DEVELOPMENT REVIEW BOARD
SUPPLEMENTAL SUBMITTAL

PROJECT NO. PR-2021-005597
Application No. SD-2022-00026

RE: PR-2021-005597/ SD-2022-00026 – PRELIMINARY PLAT

PLAT OF
LOTS 1 THRU 10
THE UNIVERSITY OF ALBUQUERQUE
URBAN CENTER
 WITHIN
THE TOWN OF ATRISCO GRANT
 IN
PROJECTED SECTION 2, TOWNSHIP 10 NORTH, RANGE 2 EAST
NEW MEXICO PRINCIPAL MERIDIAN
CITY OF ALBUQUERQUE
BERNALILLO COUNTY, NEW MEXICO
 NOVEMBER, 2021

PLAT OF
LOTS 1 THRU 10
THE UNIVERSITY OF ALBUQUERQUE
URBAN CENTER
 WITHIN
 THE TOWN OF ATRISCO GRANT
 IN
 PROJECTED SECTION 2, TOWNSHIP 10 NORTH, RANGE 2 EAST
 NEW MEXICO PRINCIPAL MERIDIAN
 CITY OF ALBUQUERQUE
 BERNALILLO COUNTY, NEW MEXICO
 NOVEMBER, 2021

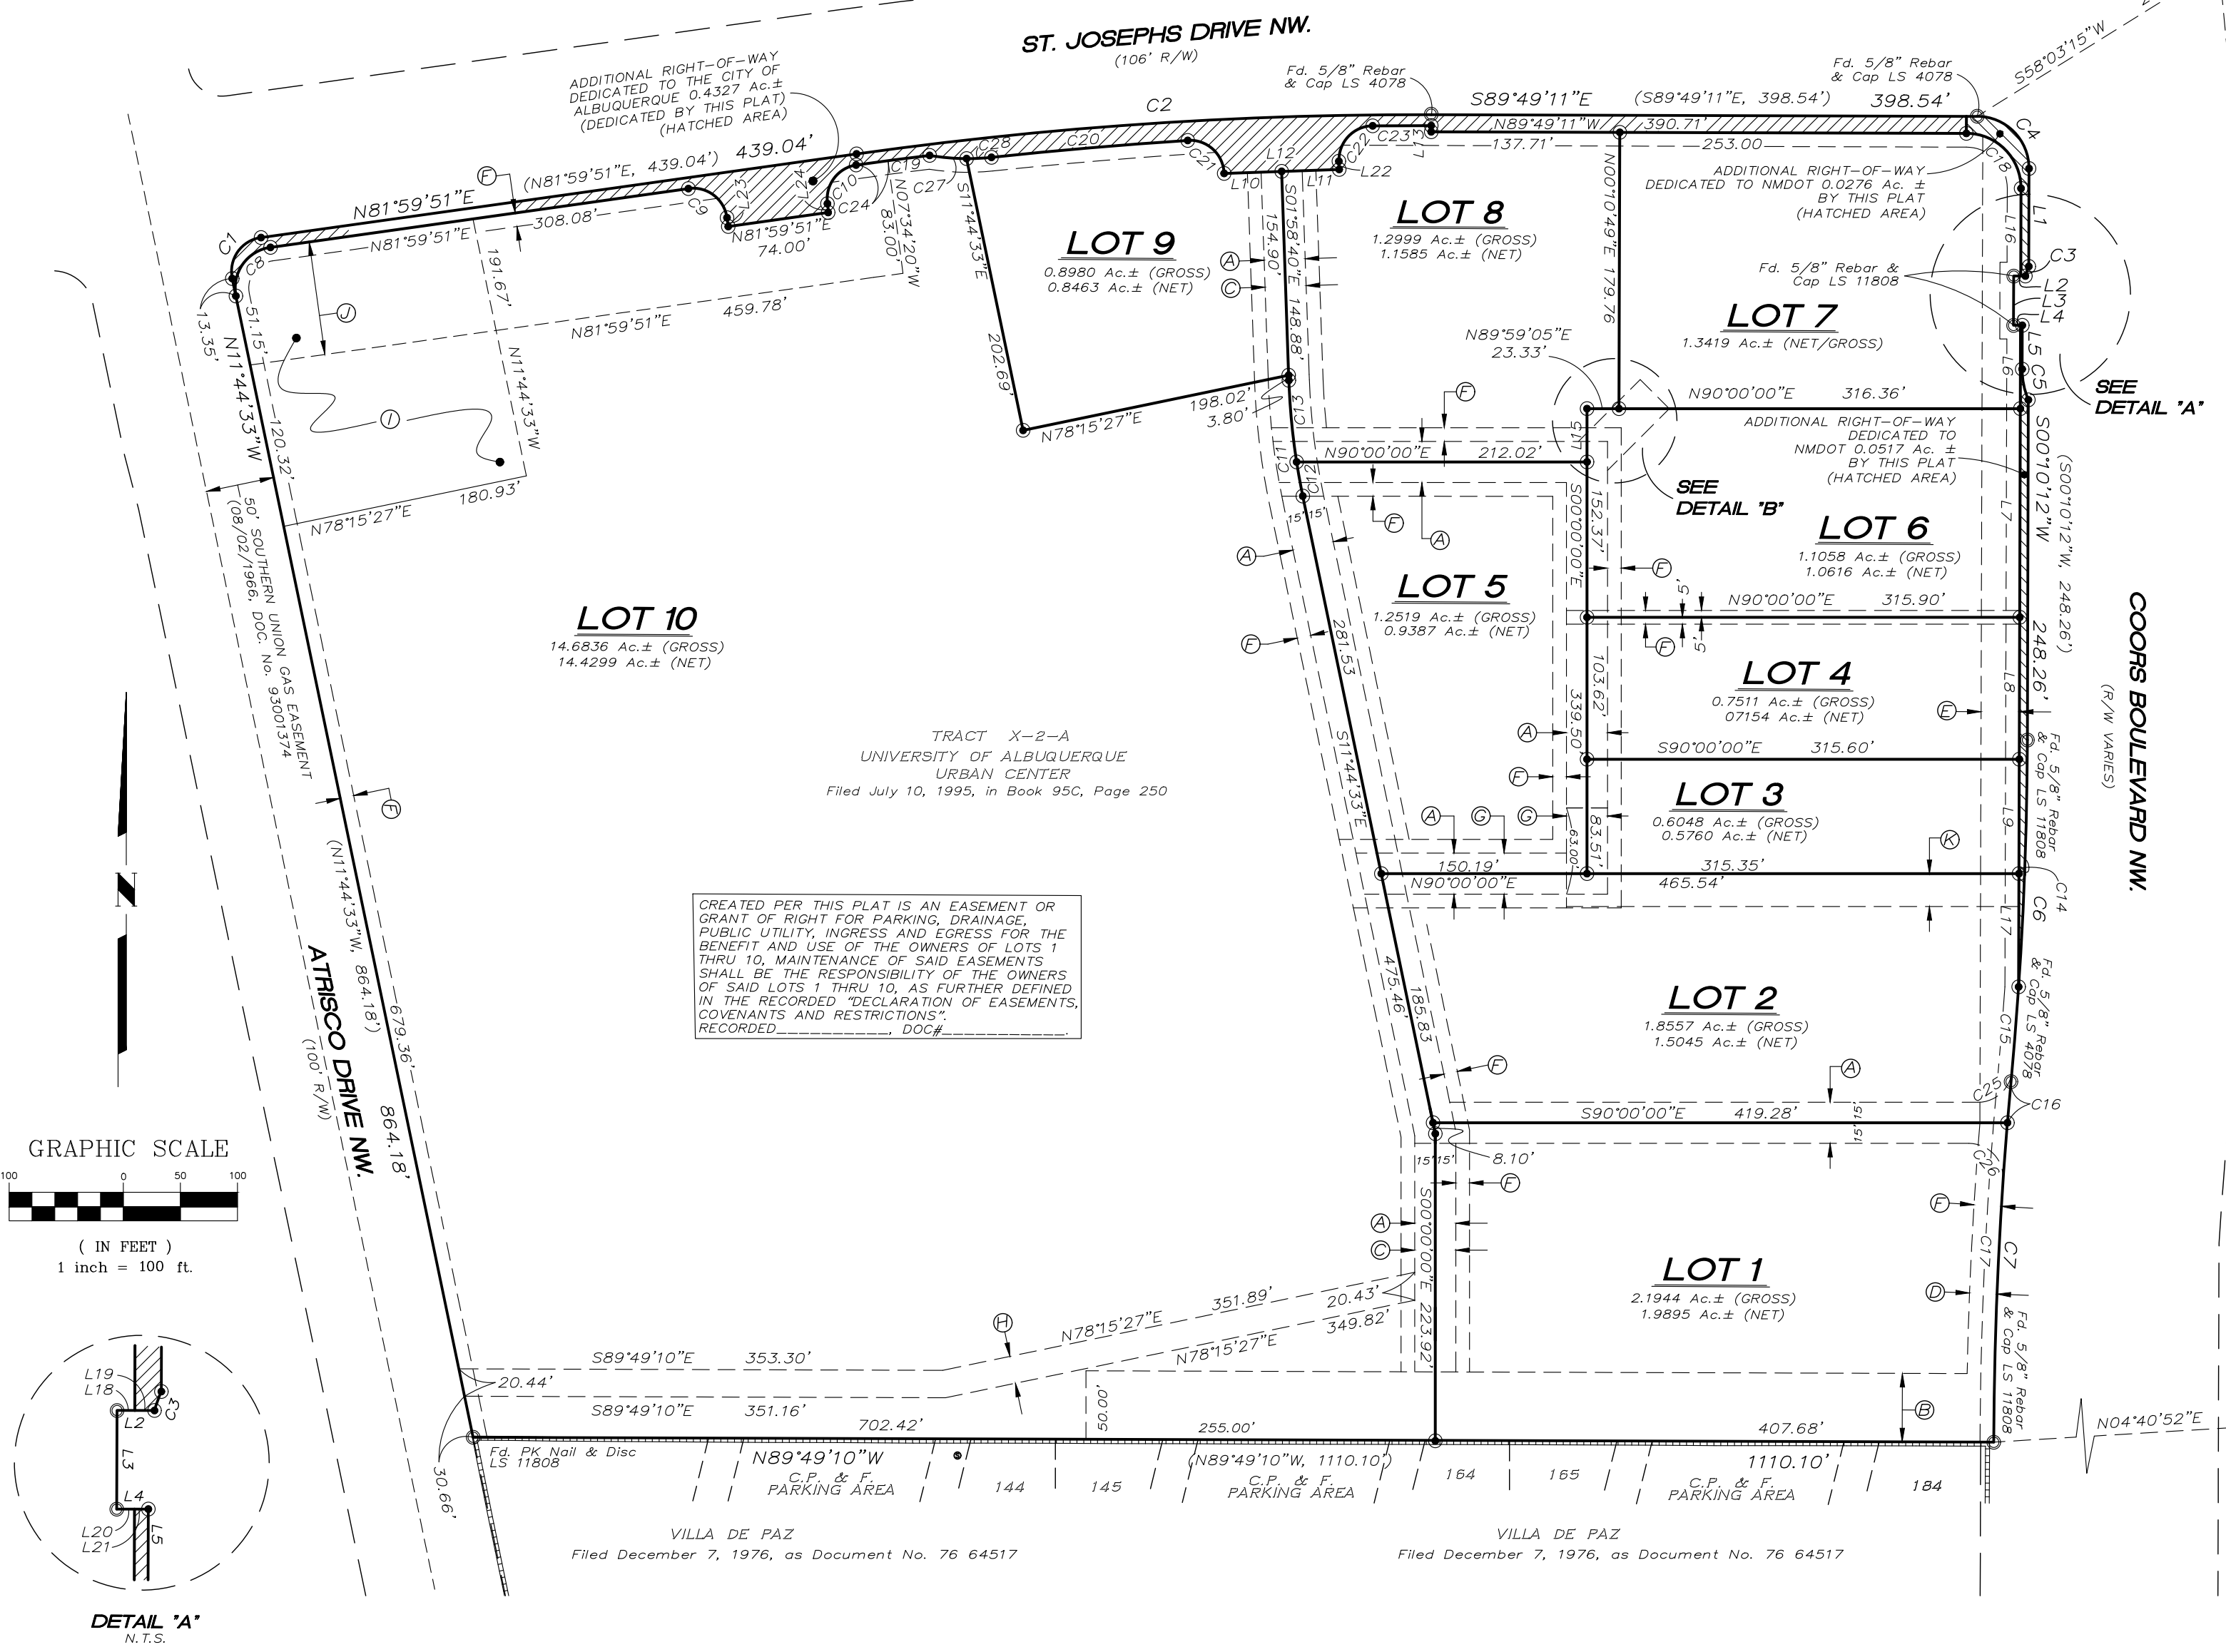
1. We need the updated Infrastructure List based on all comments associated with the list (Hydrology, Transportation, WUA)
2. The easement at the southwest corner needs to match the proposed waterline layout. If the waterline is proposed to make several turns, show that on the utility plan. Otherwise update the easement to match the straight waterline as shown on the utility plan.

1. G&D approval has been provided.
2. The wording for the existing surge pond at the northwest corner seems wrong for a plat (“Revocable and Temporary stormwater Drainage License”. Based on drainage calculations, a permanent drainage easement needs to be shown on the plat. (Has this comments been addressed).

3. There are several private drainage easements shown on the plat. However, Lot 9 does not currently have an easement going to it. Is this an oversight? Would it be better to just have a Blanket Cross Lot Drainage Easement and sheet drain the lots till you need a specific private detention pond for the lots and private storm pipe outfall connection to the existing 36-in storm drain. (Has this comments been addressed).

1. All easements need to be shown on the Plat.

Applicant Response – An updated infrastructure list has been added in this resubmittal to address all comments. The easement has been updated.

Applicant Response – G&D approval has been obtained. See approval letter in this resubmittal package. All comments have been address and infrastructure list has been amended.

Applicant Response – All easements are shown on the Plat.
